Planning Statement

BANK FARM, HIGHER LANES, HIGHER
WYCH, WHITCHURCH, SY13 3AX

April 2024

'Works to widen and increase the height of the lean-to to rear of farmhouse along with rebuilding and change of use of piggery building to provide ancillary residential accommodation including glazed recessed linkway and hard landscaping (Part Retrospective)'.

DRAWING NUMBER 22-141b REV d

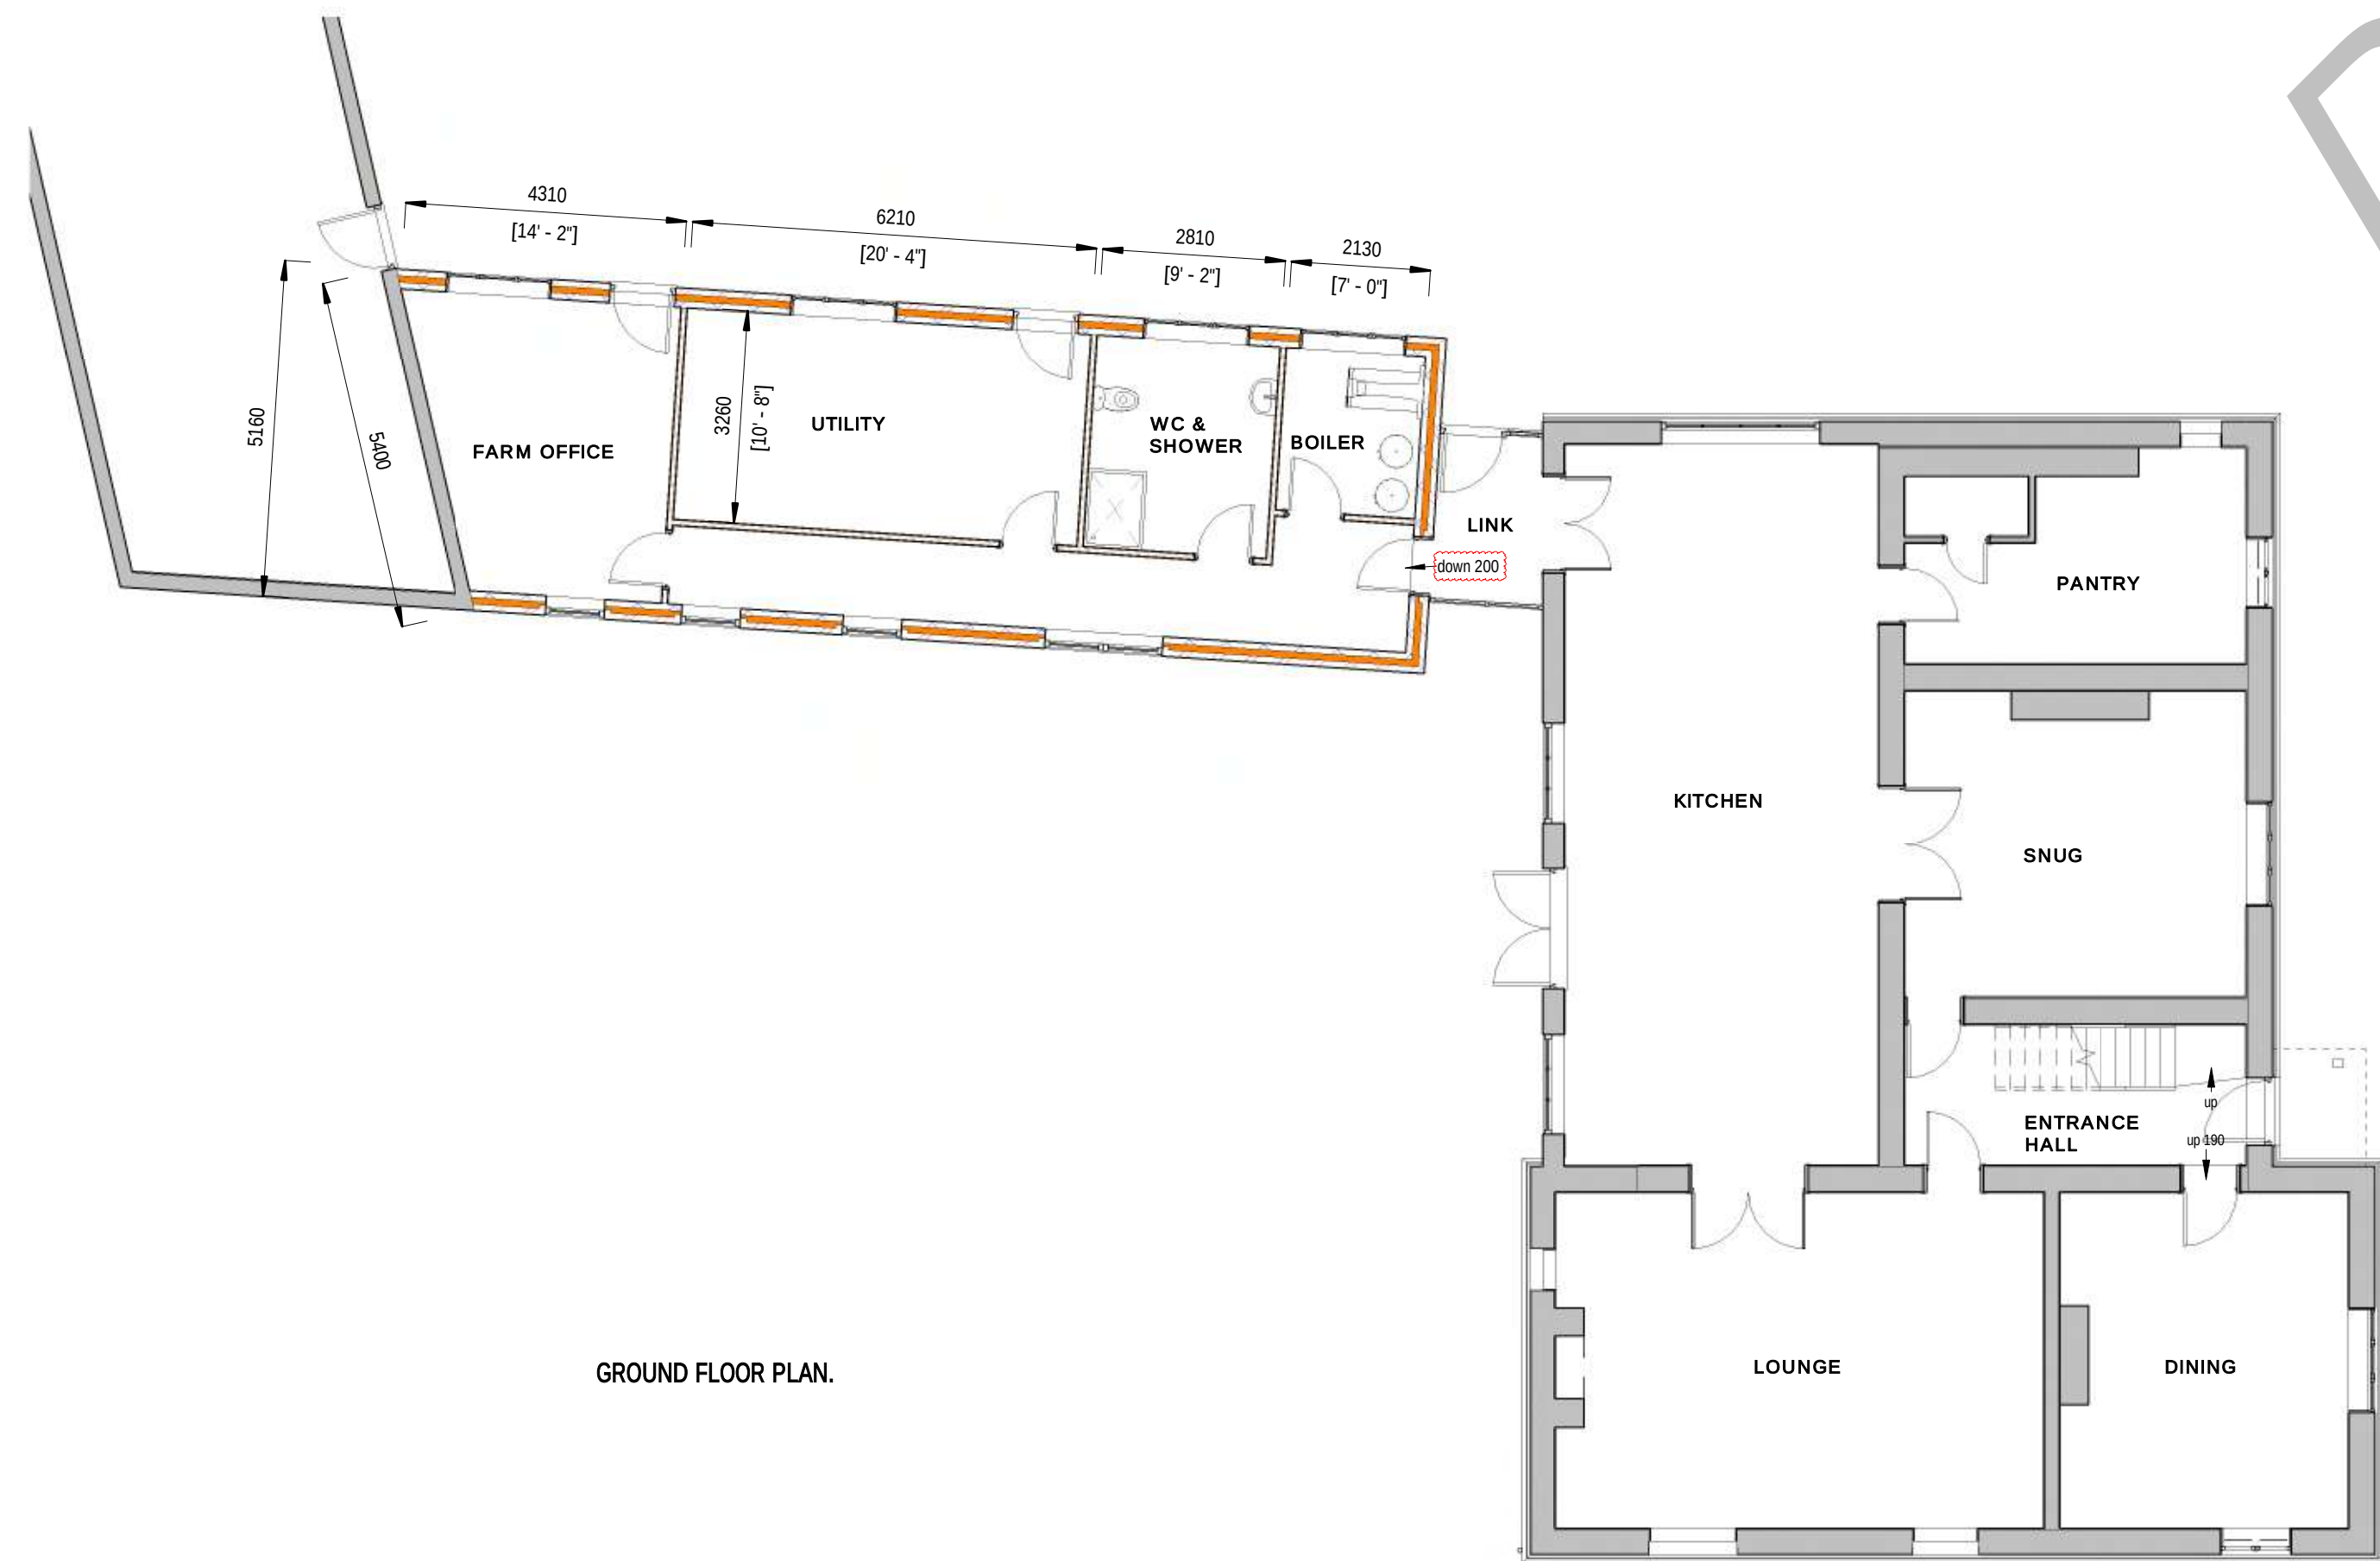
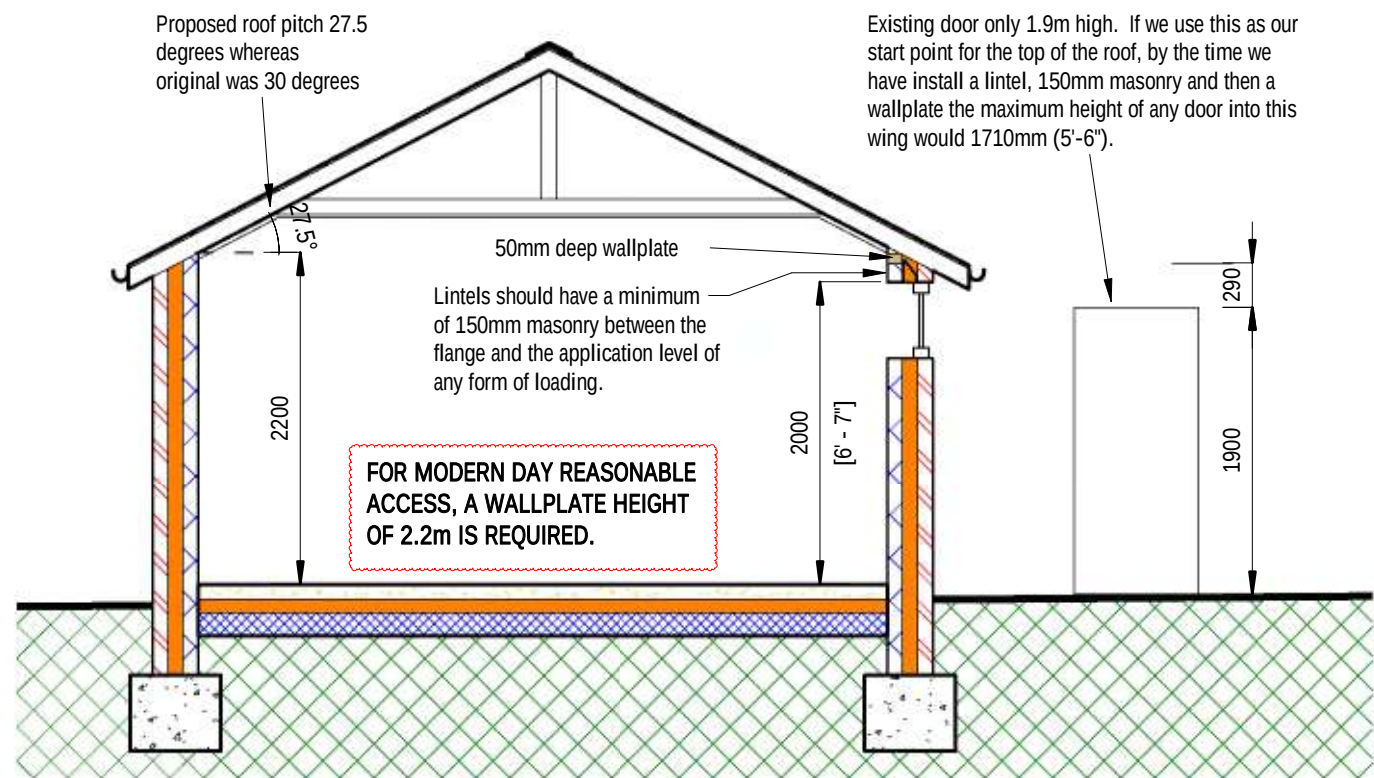
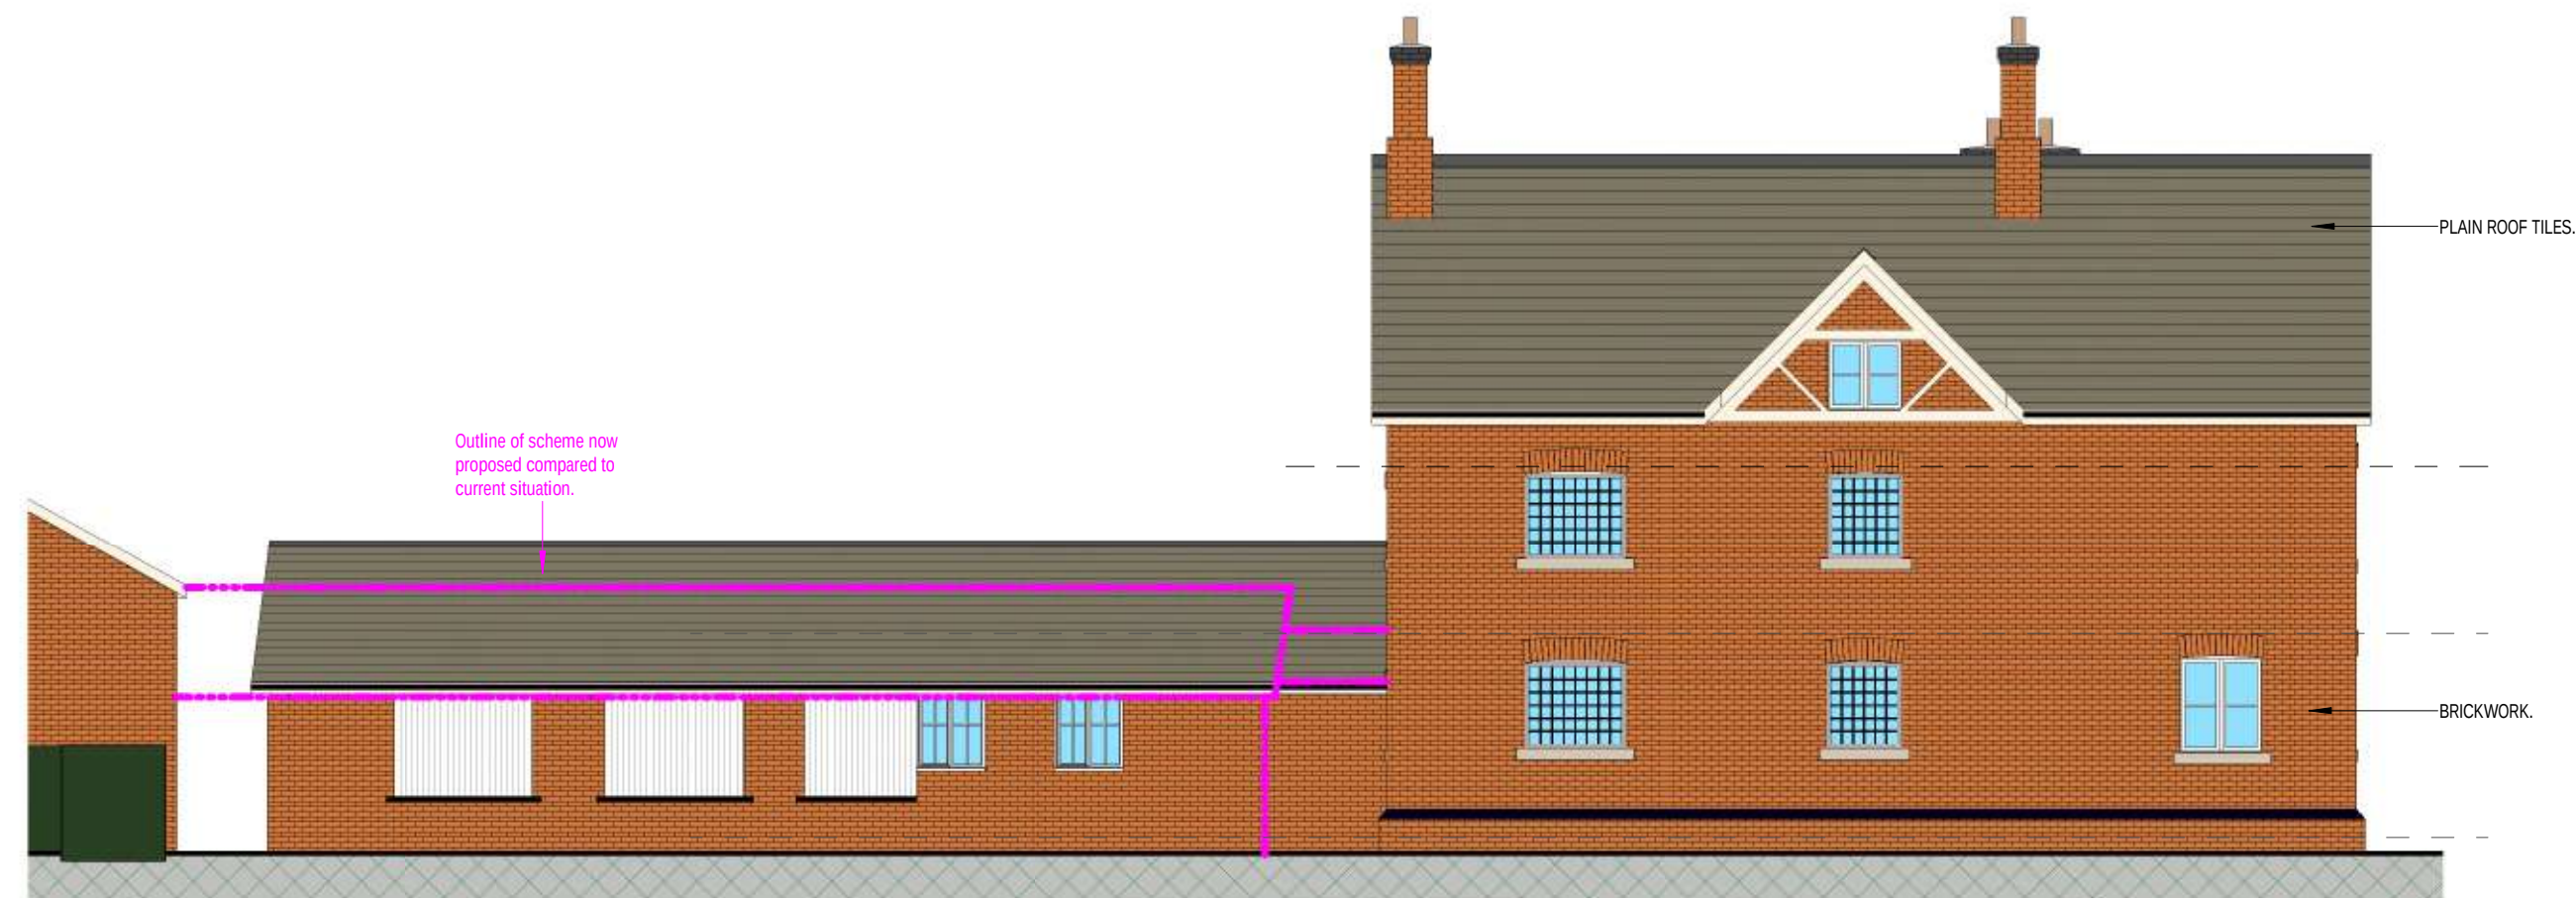
We think the proposals are positive and do a lot to address our main concerns, which was the separation of the Piggery from the multi-purpose barn range it was listed as part of. We would like to see an increase in the separation of the Piggery from the farmhouse as they were never intended to be linked, looking at the size of the rooms, the large utility room looks like it could be squeezed to achieve the reduction in length. At the same time, the link building could be extended to still provide the functional link desired. This element should be a very simple, lightweight linking structure and not compete visually or functionally with the farmhouse or barn.

Rev	Description	Date
a	Pre App Letter dated the 3 Feb 2023	17/2/2023
b	Planners email dated the 20/4/2023	20/4/2023
c	Link Amendment	28/4/2023
d	Piggery Partly retained	28/11/2023
